Stirling City Centre

I have visit the open day at Saturday 20th September 2008 at Stirling Civic Centre and would like to make the following commends to the Stirling City Centre Alliance Survey:

Figure 2 reduced size land bridge

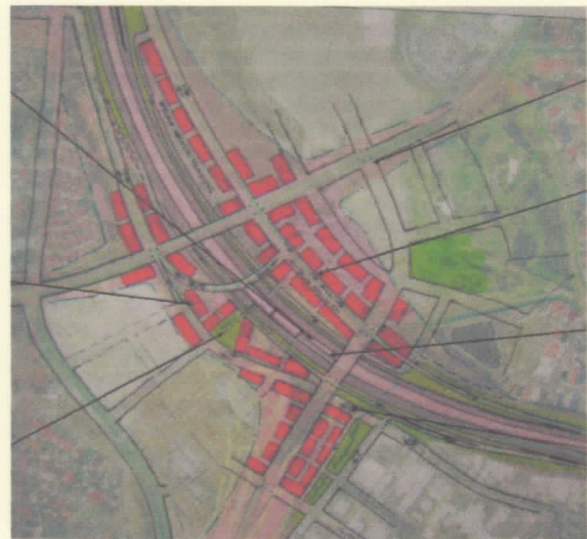
The website 'POSSIBLE STATION PRECINCT - AUGUST 2008' shows a densely build up area on both side of the freeway and there is no indication of the connection other than that little 'POSSIBLE LAND BRIDGE OVER FWY'.
